**Design Addendum**

For Reselton Properties

This Design Addendum has been prepared in direct response to a series of comments provided by London Borough of Richmond Upon Thames regarding the submitted proposals for the former Stag Brewery site in Mortlake.

Block 1 (cinema) - Proposed south elevation

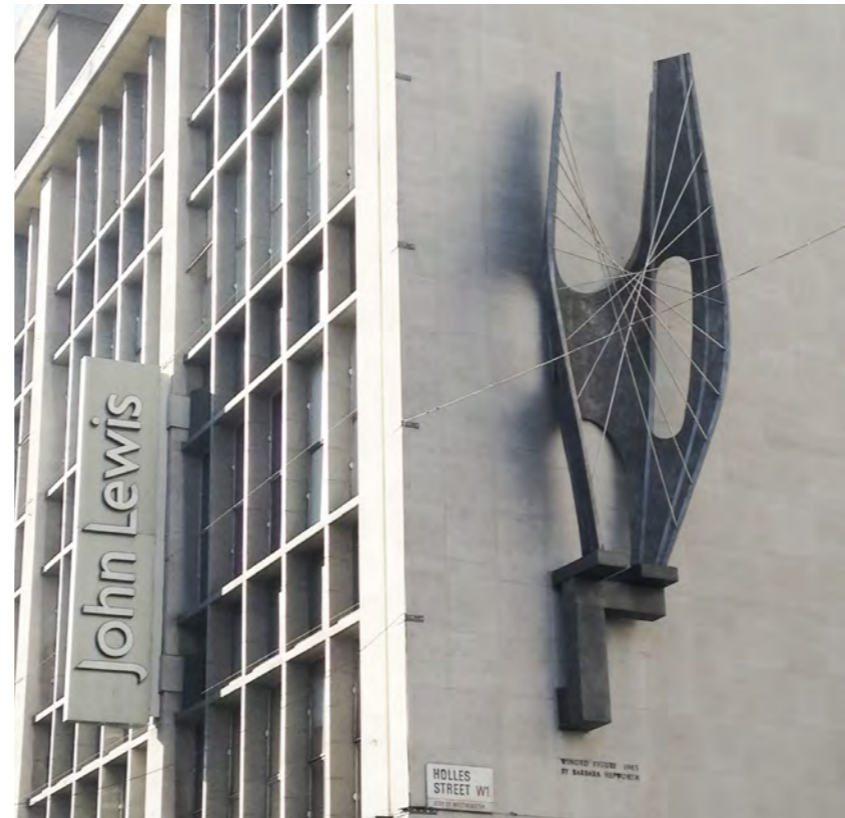
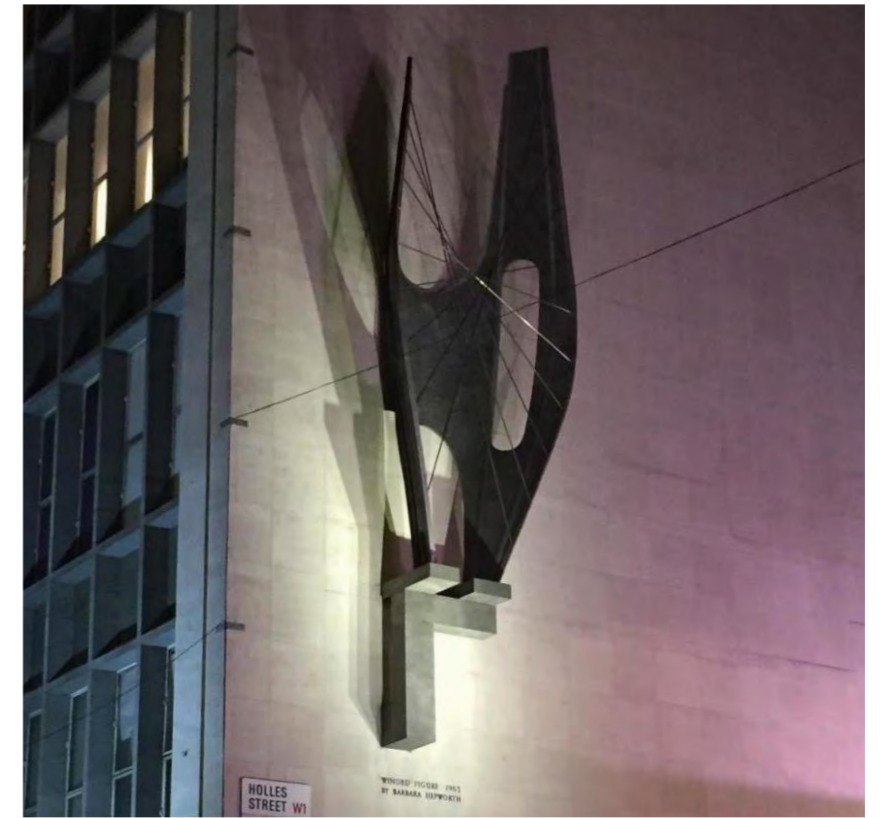
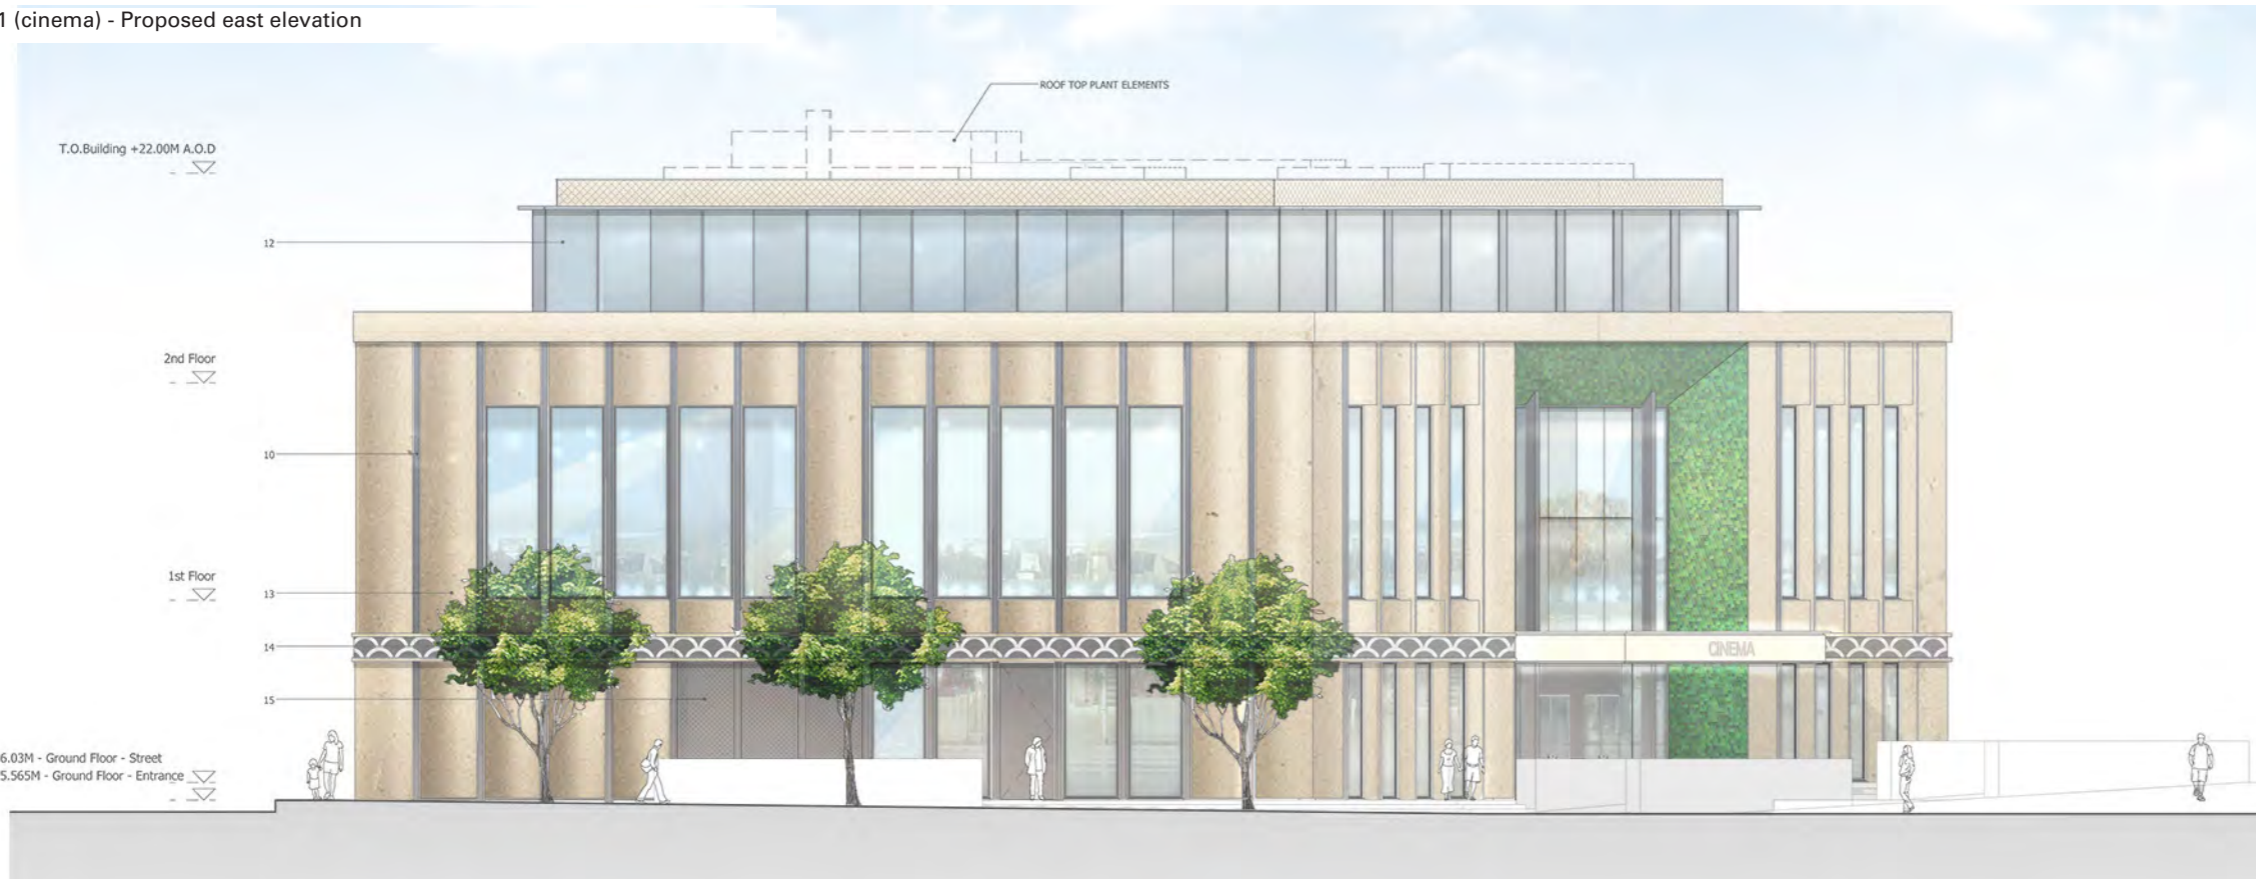
4. Provide active frontages

The proposed south and east facades are proposed to incorporate significant areas of glazing that respond to the public realm. The south elevation faces on to Lower Richmond Road and Mortlak Green and does not overlook any other properties. The east elevation faces on to the entrance to the Green Link and is set apart from the building opposite (B6) by 38m.

While there is limited opportunity to increase the amount of glazing to these facades, there could be potential to further animate these elevations by incorporating lighting and/artwork features which could be conditioned.

Submitted view of proposed cinema (Block 1) from Mortlake Green

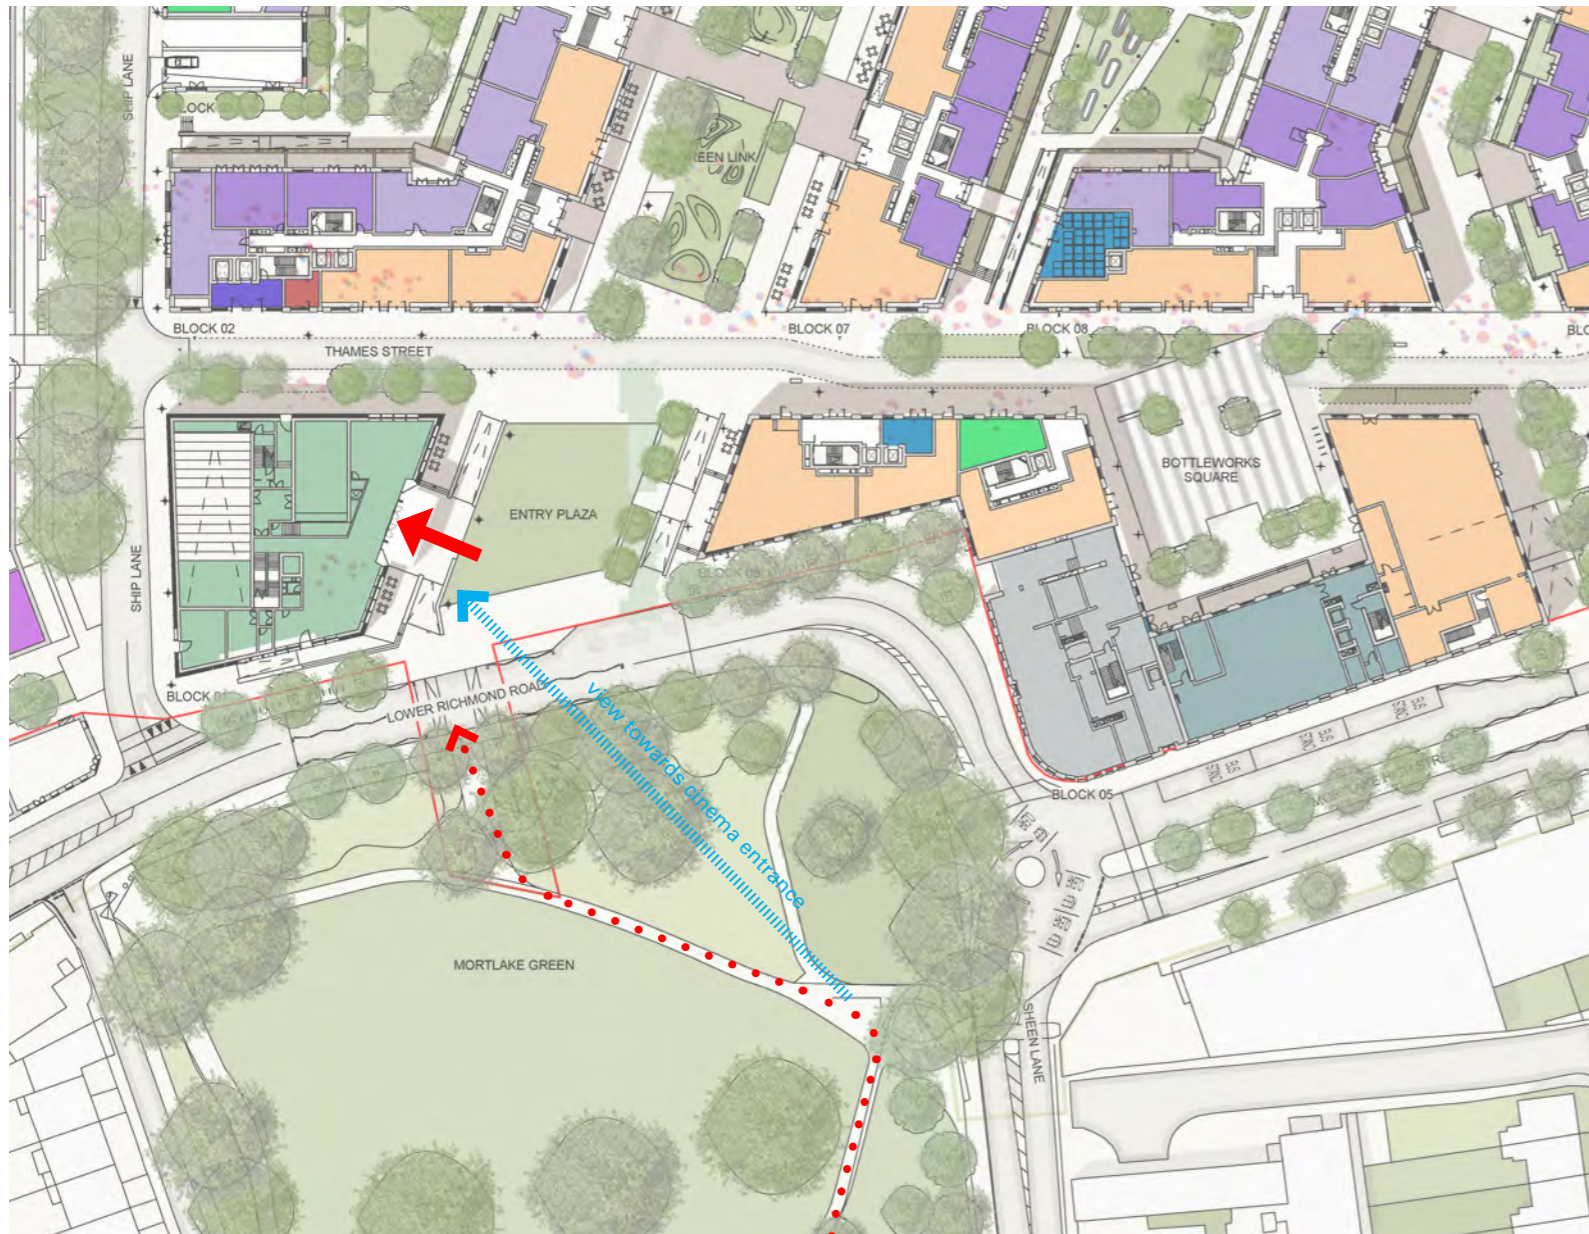
### 5. Relocate the entrance of the cinema.

The entrance to the cinema has been deliberately located on the east location to benefit from a more generous spill out space and to serve as an important civic gesture. We believe that relocating the entrance to face Lower Richmond Road would disrupt pedestrian flow along the pavement and increase the risk of pedestrians spilling on to the busy road. Aside from this, we do not believe this position would be as welcoming and prominent due to the angle of approach from the station through the park. Aside from these technical constraints, it is worth noting that an important design feature of the entrance is to have a double storey height angled reveal, which is proposed as being clad in a 'bottle green' coloured tile. This will be visually prominent in the views on approach from the station and village green.

Block 1 (cinema) - Proposed basement level plan

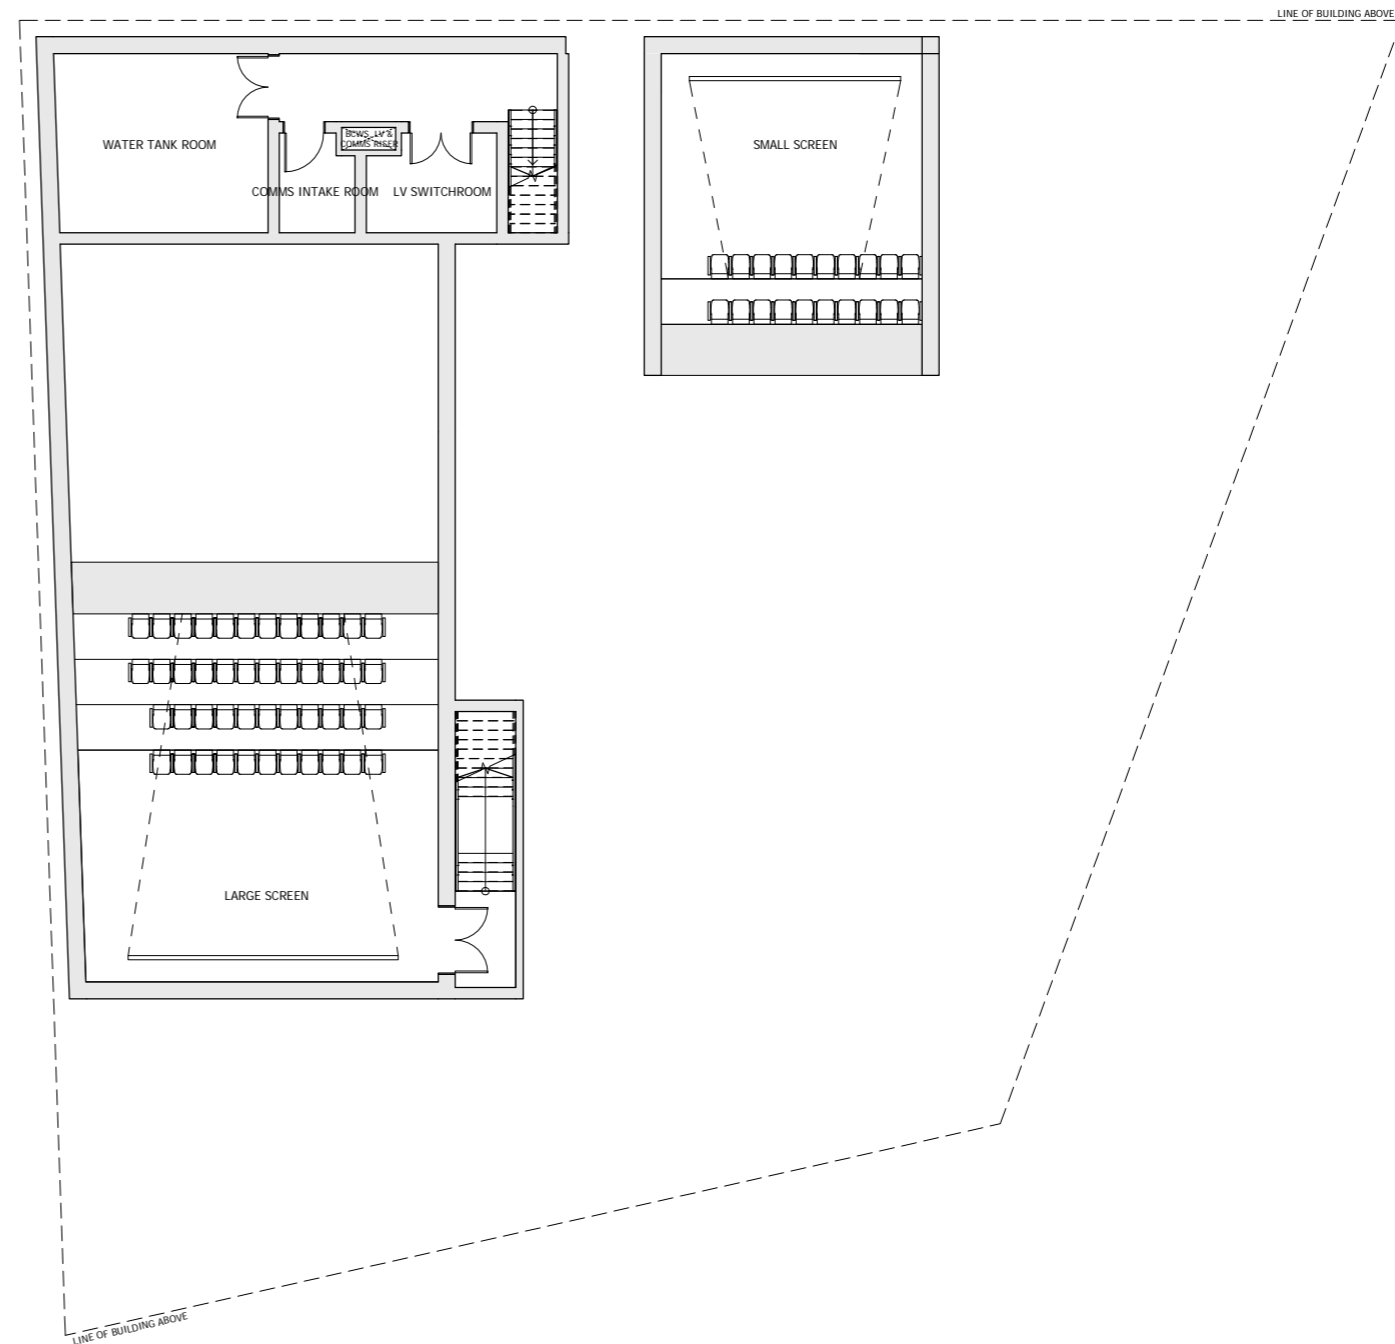
- 10. Cinema basement not shown on plan. Why can't the basement be lowered to provide level access?

Please see response to item 2. It is worth noting that the levels around the cinema facades vary, and that the internal level has been set to provide level access to the entrance on the East facade. The basement level consists of very small areas of basement - most of which are raked floors to cinema screens. These basement areas are not affecting the setting out of ground floor level datum.

Block 1 (cinema) - Proposed south elevation

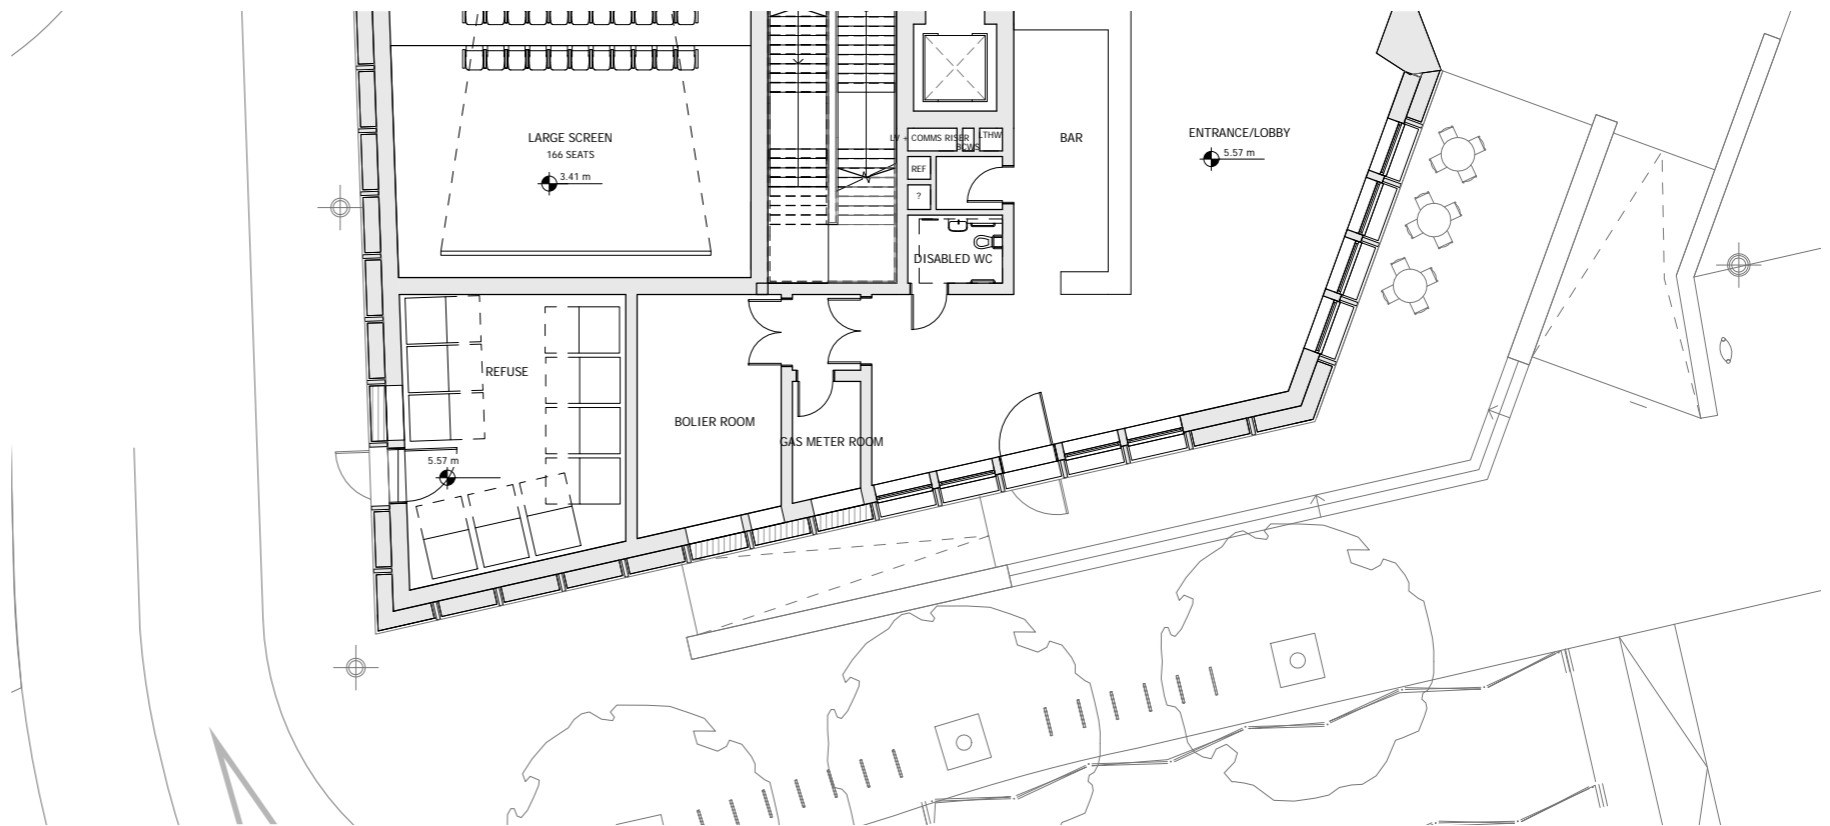
13. South elevation has a poor relationship with street: Refuse, boiler, second entrance.

14. As mentioned in earlier paragraphs, the cinema screens have been arranged to avoid overlooking issues with residential buildings opposite. These screen occupy most of the North and West facades. This leaves very little opportunity for the incorporation of refuse store and boiler rooms - which must have direct access from the street. The refuse cannot be collected from Lower Richmond Road since this would cause disruption to traffic. It is for this reason that it has been positioned on the corner of Ship Lane. The boiler room requires ventilation and must be positioned on a facade - it must also be positioned in a location where the flue can terminate in the set back rooftop level and so that service routes can be distributed easily to both cinema screens. It is for this reason that the North facade was discounted as a suitable location.

Revised view of corner elements to Buildings 2 and 7 (facing the entrance to the green link)

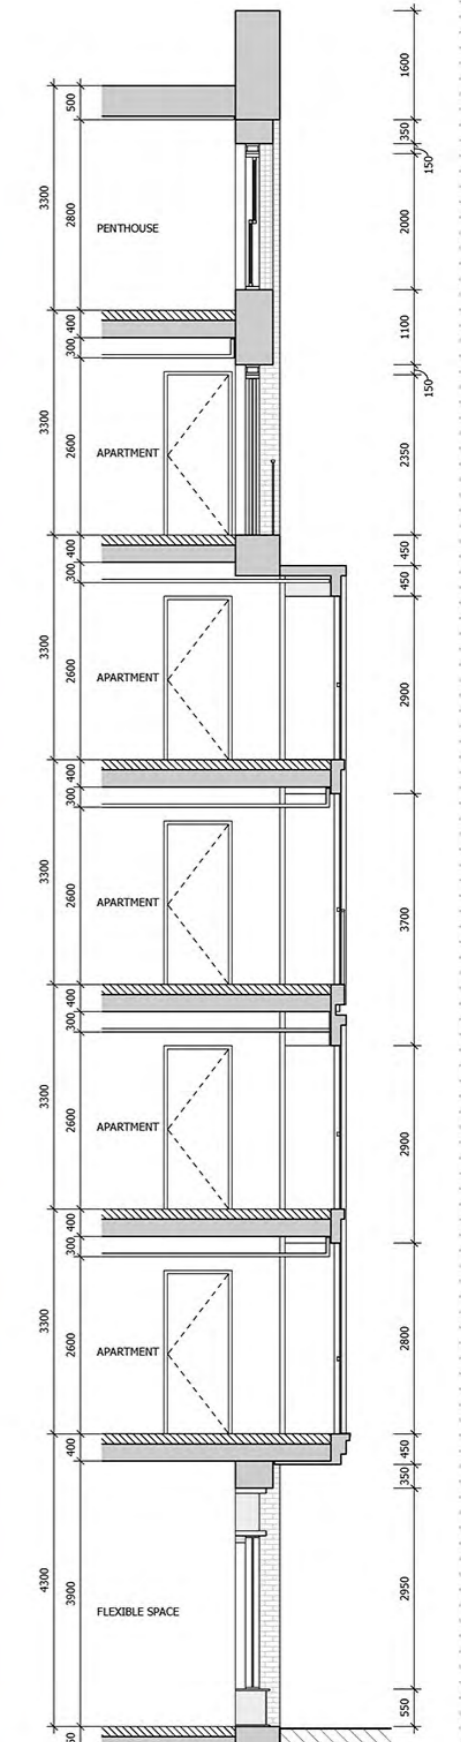
### 1. Turret needs refinement/ elegance

Corner 'turrets' are proposed to three strategic corners of mansion buildings. These elements aim to draw from historic precedent in terms of their design as well as serve as welcoming gateways elements that frame the view of the green link.

Each of the turret elements on buildings 2, 7 and 8 have been re-considered to provide hierarchy of window openings and a more refined top to the building - the result being an appearance more akin to historic precedents of mansion turrets that were built during the Victorian era across London.
